LOCATION: Prairie Creek Road, west of Clearfield Road

REQUEST: An application to create one 2.214-acre (96,454-square foot) lot from a tract of land in City Block 7845 on property located on Prairie Creek Road, west of Clearfield Road.

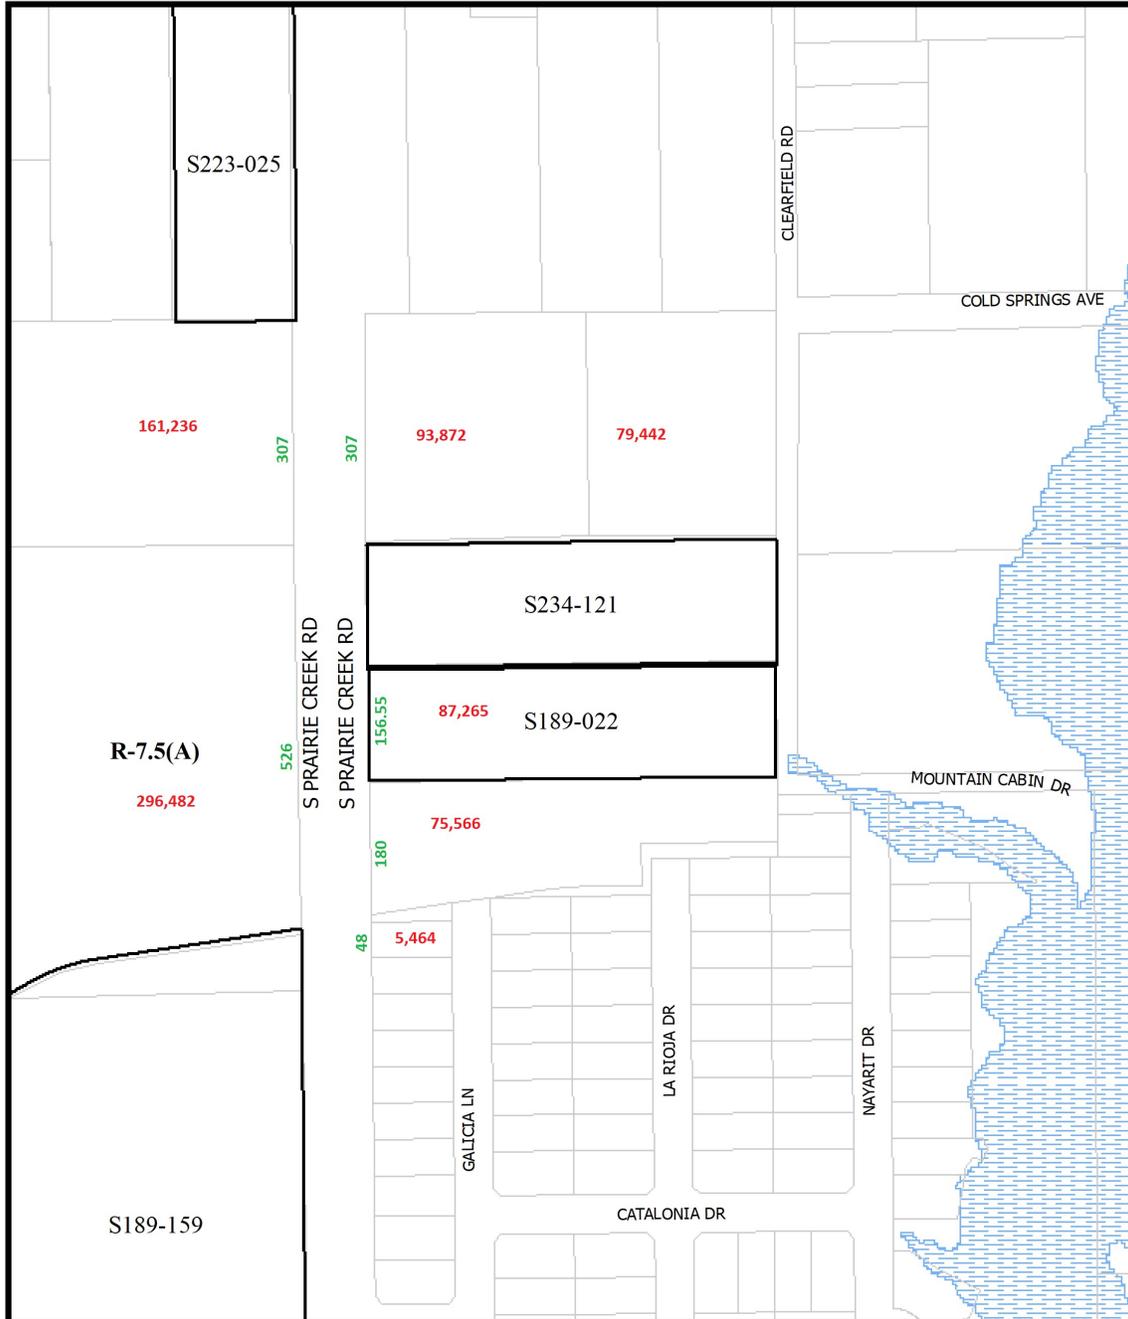
21. On the final plat, change "Clearfield Road" To "Clearfield Road (FKA Lea Road)".
22. On the final plat, add "Nayart Drive" to plat drawing.
23. On the final plat, change "Prairie Creek Road" To "Prairie Creek Road (FKA Branfield Road FKA Brock Road)".
24. On the final plat, change "LA Prada Drive" To "LA Rioja Drive".

25. On the final plat, identify the property as Lot 1 in City Block C/7845.
